**CONDITIONS FOR CASK USE AND  
TECHNICAL SPECIFICATIONS  
DOCKET NO. 72-1007  
CERTIFICATE OF COMPLIANCE NO. 1007  
AMENDMENT 2**

## REVISION HISTORY

FIGURE 1

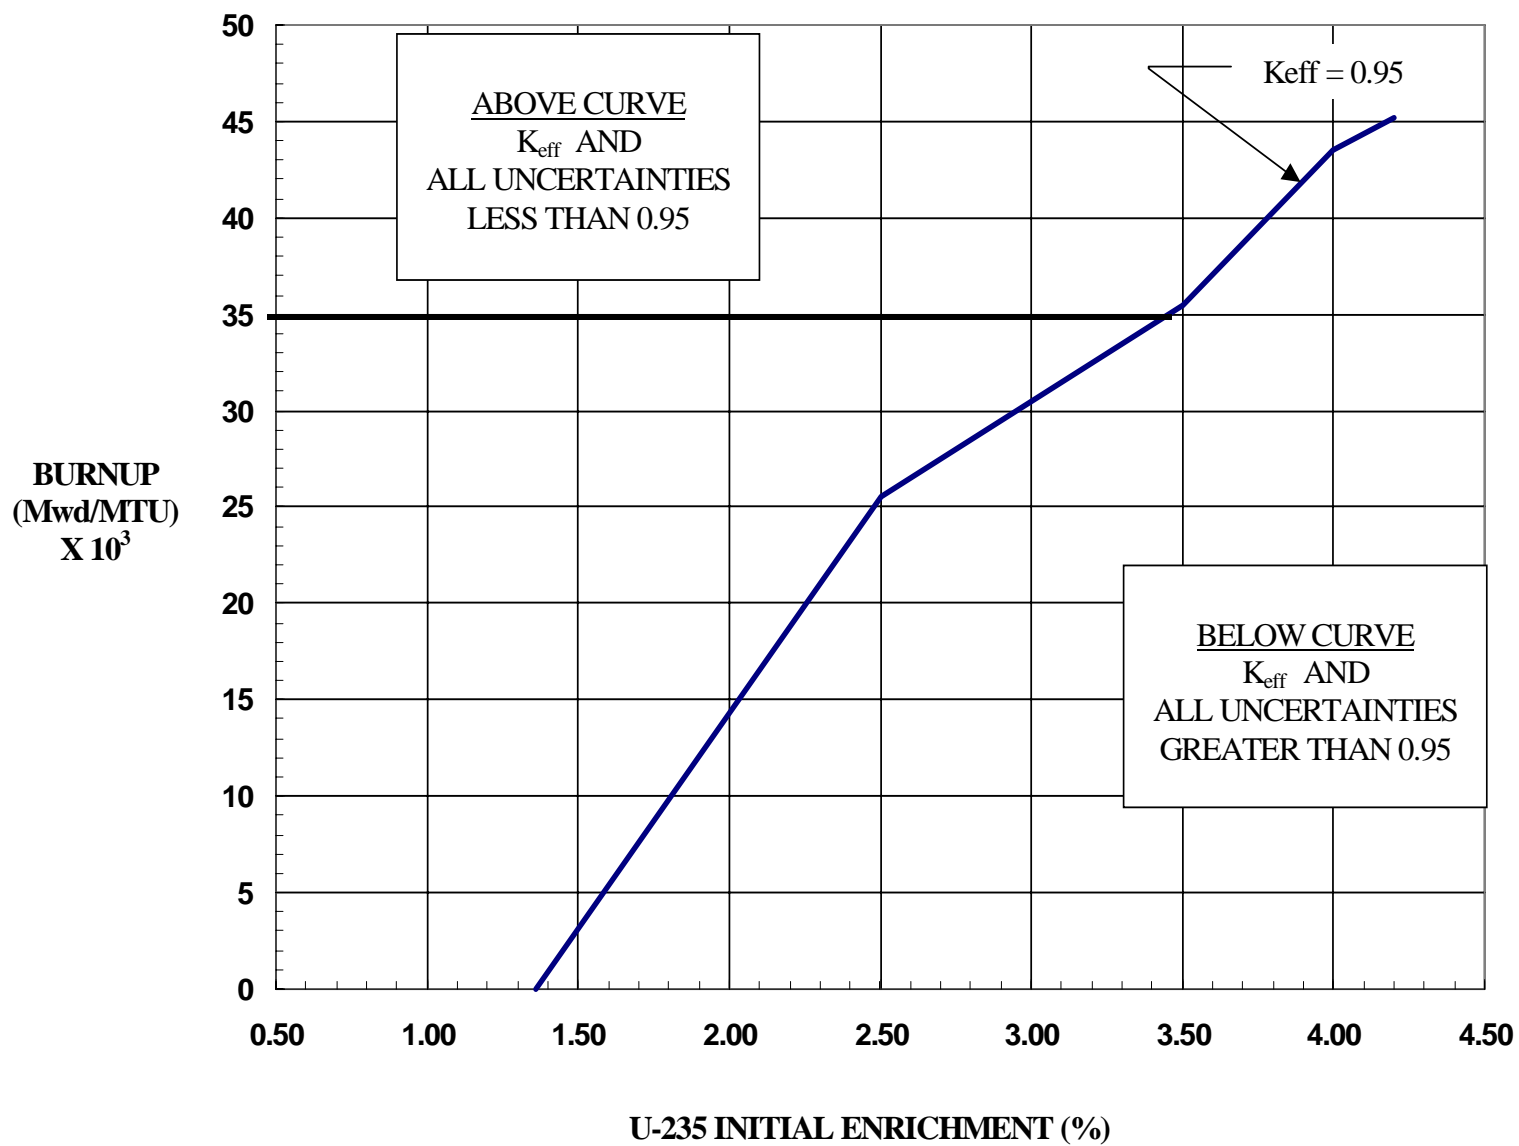
1.2.1	Deleted extraneous text and references to the SER and SAR, spelled out mathematical symbols, and truncated curve in Figure 1 at 4.2% initial enrichment.

initial enrichment and fuel irradiation that satisfy these criteria are shown in Figure 1. This Fuel Criticality Acceptance Curve represents the minimum burnup required for fuel assemblies of various initial enrichments to achieve a reactivity equivalent to an enrichment less than or equal to 1.35 weight percent  $^{235}\text{U}$ . For irradiated fuel assemblies with an initial enrichment and burnup that fall above the curve,  $K_{\text{eff}}$  will be less than 0.95 when flooded with fresh water, and, therefore, the fuel assemblies are acceptable for storing in the VSC-24 cask, provided they also comply with the other characteristics of specification listed in Table 1. Irradiated fuel assemblies with initial enrichment and burnup that fall below the curve are unacceptable for loading in the VSC-24 cask.
